HISTORIC AND DESIGN REVIEW COMMISSION

HDRC CASE NO: 2022-346
ADDRESS: 506 STIEREN
LEGAL DESCRIPTION: NCB 2966 (STIEREN STREET REPLAT), BLOCK 1 LOT 18
ZONING: RM-4, H
CITY COUNCIL DIST.: 1
DISTRICT: King William Historic District
APPLICANT: Caroline Gado
OWNER: APOLLO MAYORAL LLC
TYPE OF WORK: New construction of four, multi-story structures
APPLICATION RECEIVED: June 13, 2022
60-DAY REVIEW: Not applicable due to City Council Emergency Orders
CASE MANAGER: Rachel Rettaliata

REQUEST:

The applicant is requesting conceptual approval to construct four residential structures on the lot addressed 506 Stieren. The proposal includes three, 3-story structures and one, 2-story structure.

1 UNIT-1 FRONT ELEVATION- NORTH
SCALE: 1/4" = 1'-0"

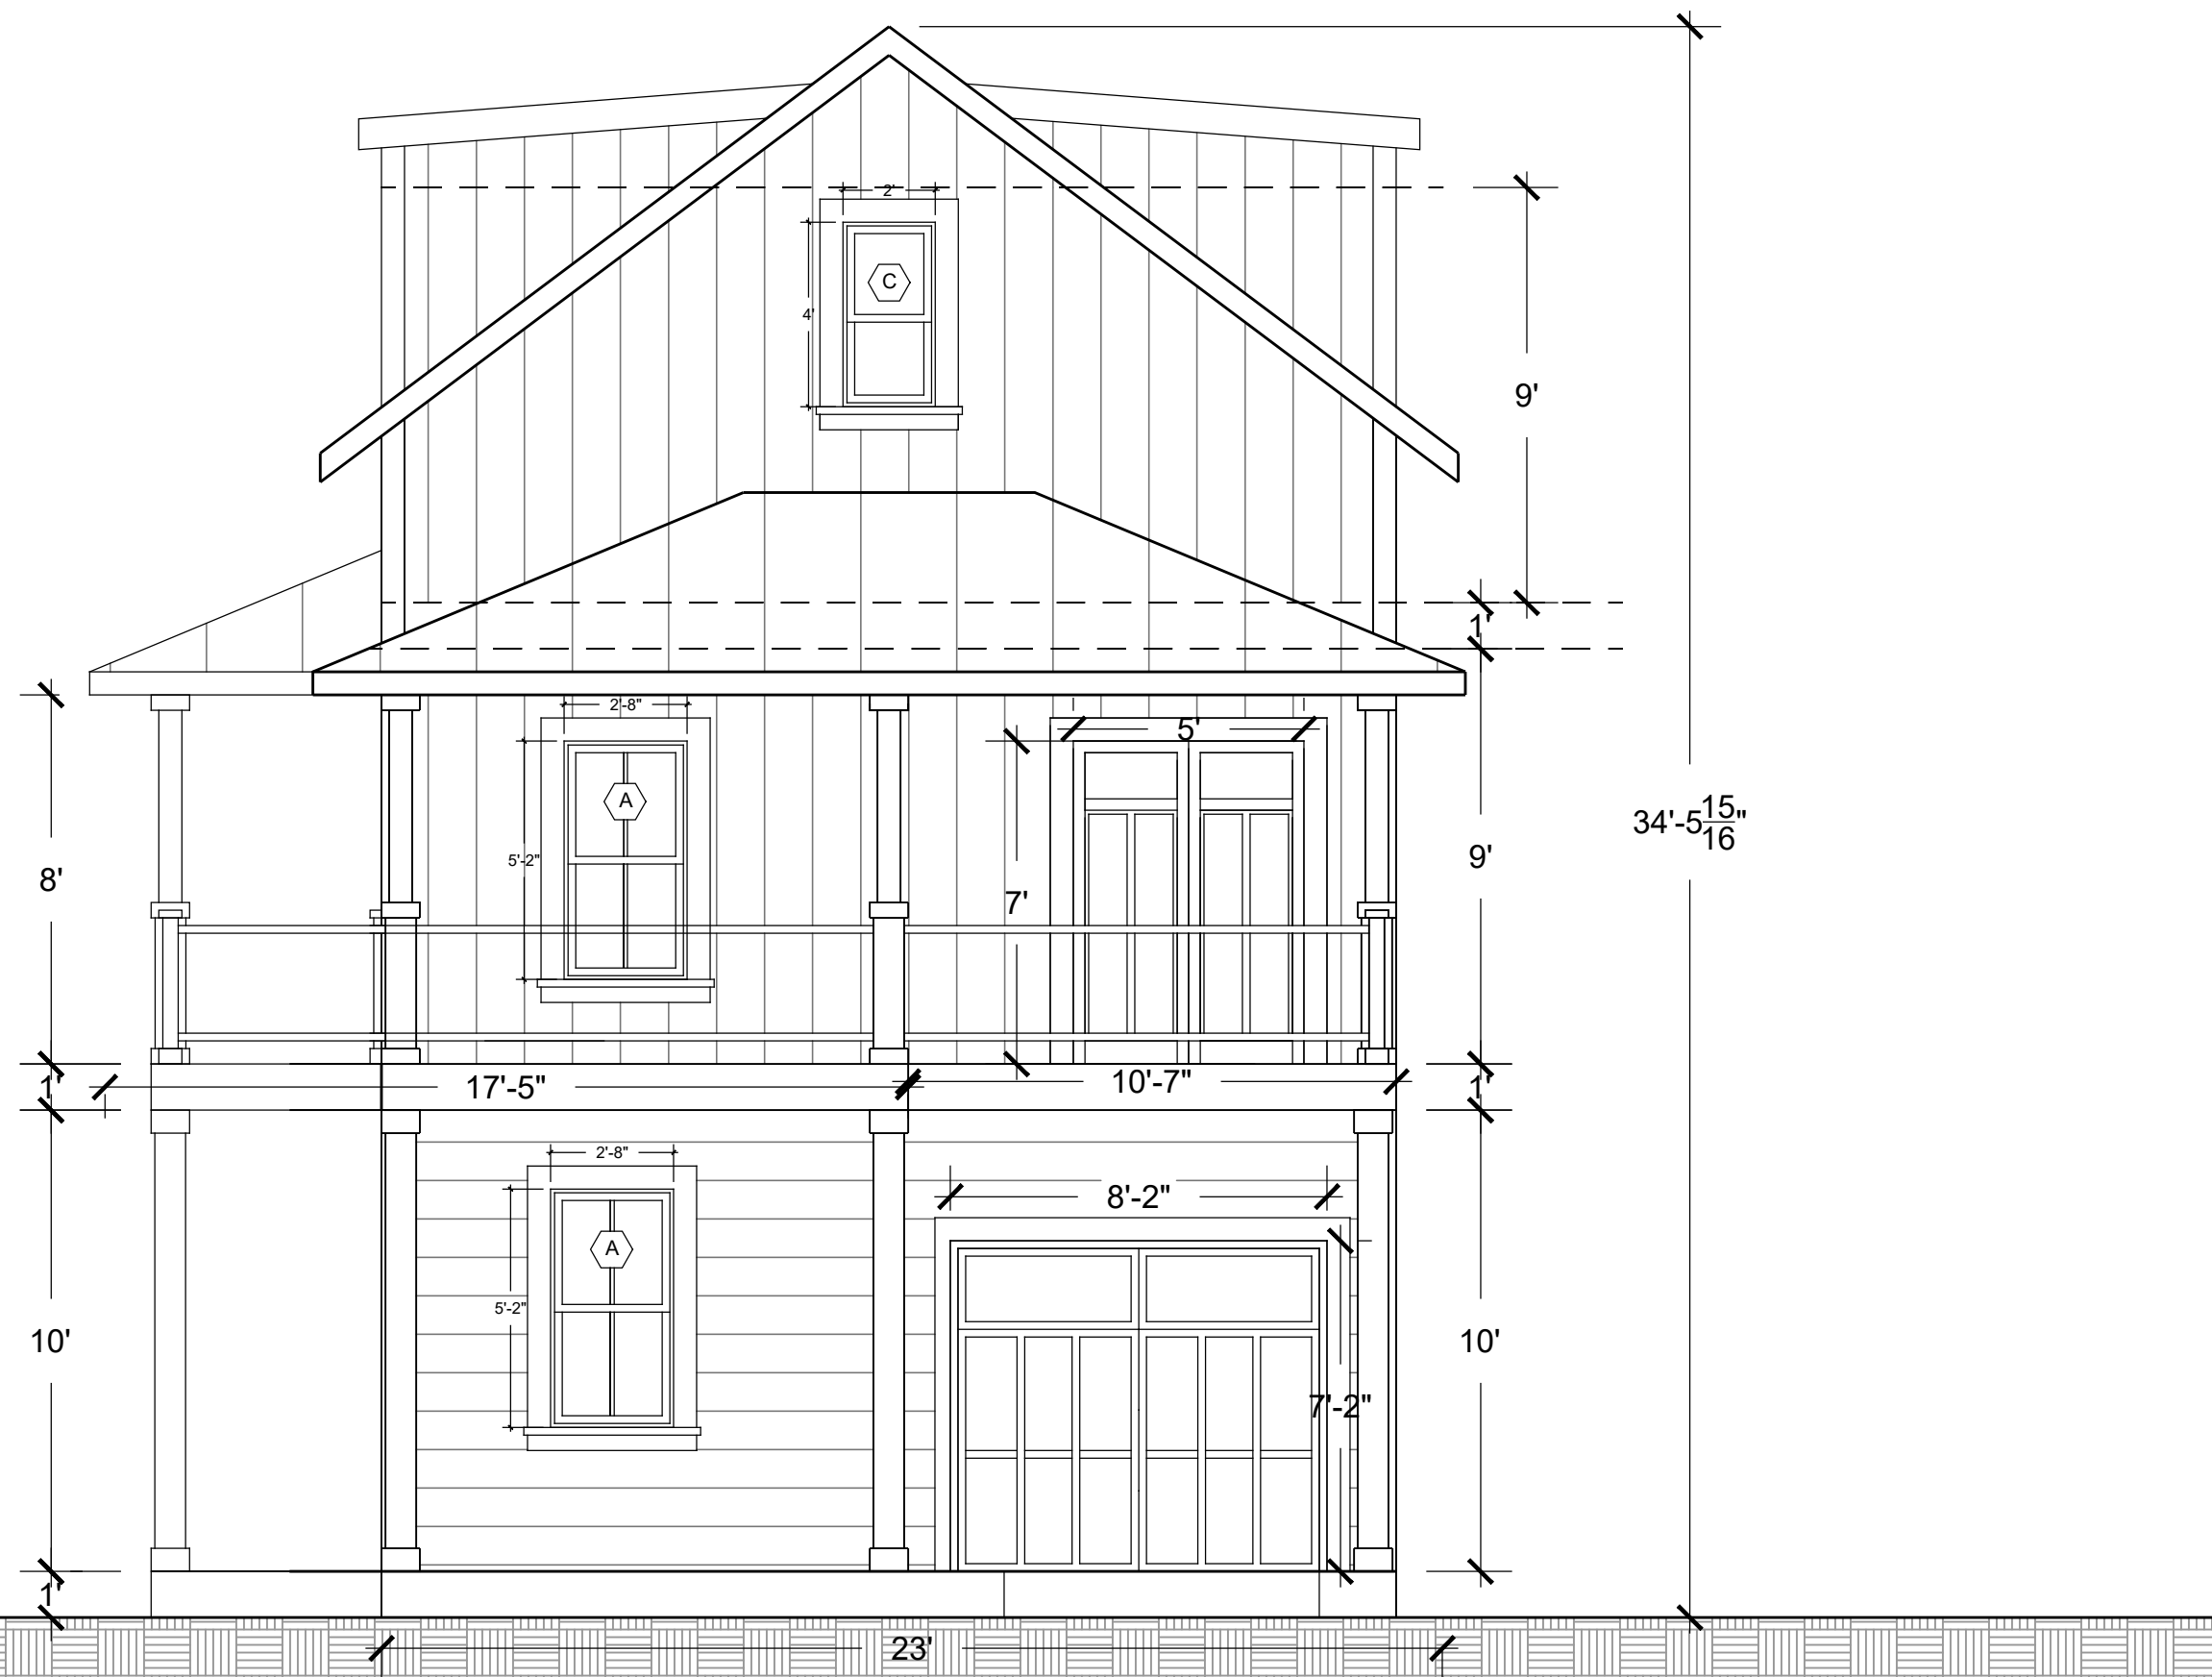
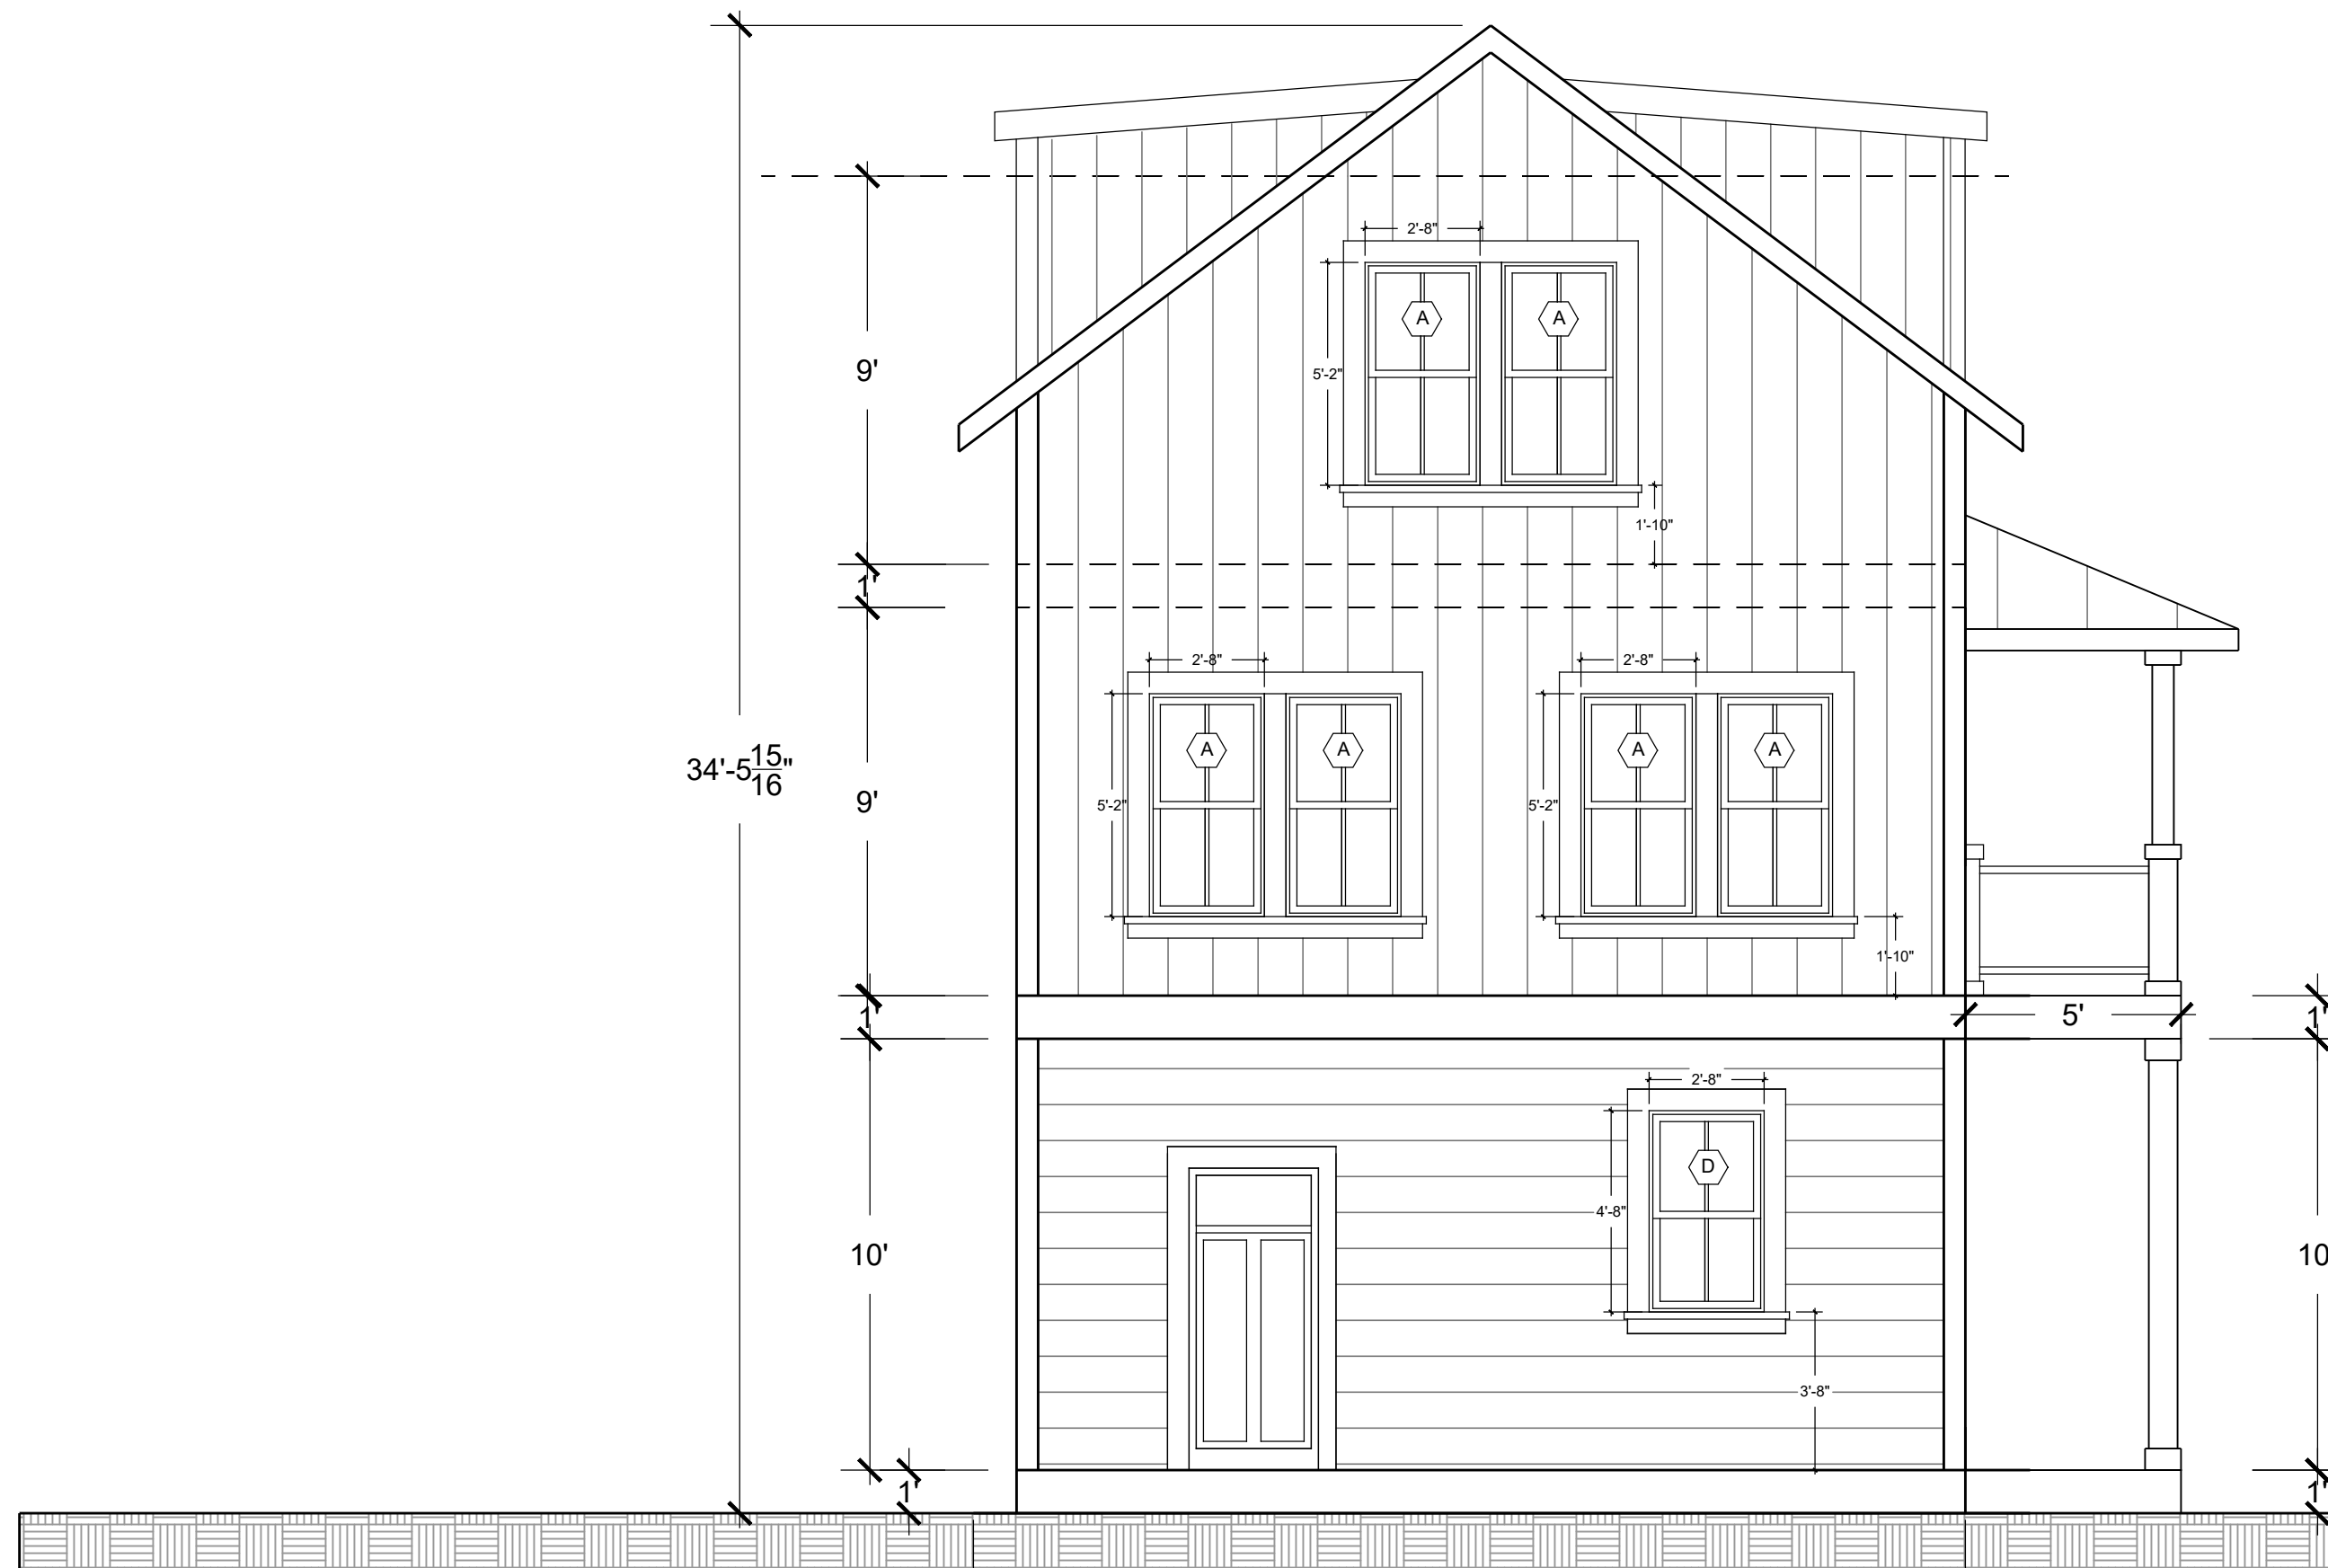
- g. **SCALE & MASSING** – The applicant has proposed to construct four detached residential structures, including three, 3-story residential structures and one, 2-story residential structure. The front building along Stieren will feature the tallest height at approximately 34'-6", with the remaining houses stepping down in height as the lot moves south from 33'-3" to 30'-9" to 27'-3". According to the Historic Design Guidelines, new construction should not exceed the height of the majority of existing structures by more than 1-story. The predominant surrounding residential context features 1-story residential and commercial structures. While there is presence of 2 and 2.5-story historic structures peppered along Cedar St, these taller structures typically feature a deeper setback than the 1-story structures. Staff does not find the proposed height consistent with the Guidelines.

- h. **ENTRANCES & PORCHES** – The applicant has proposed porch elements on all four structures. The front building along Stieren features a wraparound 2-story porch with a depth of 5 feet. The remaining interior buildings feature porches on the front facades fronting the shared interior driveway with varying depths that include recessed single-stall carports. Per the Guidelines for New Construction, The primary façade of new buildings should be in keeping with established patterns in terms of porches, entrances, orientation, and setbacks. Staff generally finds the front setback and porch design conceptually consistent, but as noted in finding f, finds the scale and massing inconsistent with the Guidelines. The height of the front building when combined with the narrow setback is also incongruous with overarching development patterns, which typically feature 1-story structures closer to the street and taller structures (2 to 2-½ stories) set further back from the street as noted in finding d.

CG: One “main” unit and 2 smaller units, the smallest unit at the rear, there are not garages, but there are covered patios. The main unit has big windows. Unit 2 is more narrow, same window styles. There is a covered porch on the first level. Unit 3 is similar to Unit 2. Unit 4 is the smallest of the 4 units, it is 2 stories but with the same front doors and window styles.

LG: Is the main structure oriented toward Stieren?

CG: The front doors are all oriented toward the neighbor, closest to Stieren. This is platted as just two of the lots.

LG: It looks like this development does not comply with the Design Guidelines. The Guidelines state that buildings should respect those that exist in the neighborhood, what’s the primary orientation of houses in the district. The Conservation Society would likely recommend a denial. Something that might work would be two units, like with your other project. And you will also need to consider the lot coverage, open space to coverage space. People who live in King William like the houses to face the street and this configuration is not normally acceptable in a historic district.

- ii. That the applicant increases the setback of the front unit to be more consistent with the development pattern of the district as noted in findings g and j.

- iii. That the applicant reduces the height of the front structure to 2 ½-stories as noted in finding f.
- iv. That the applicant reduces the heights of all three of the rear three structures to be subordinate to the primary structure as noted in finding f.
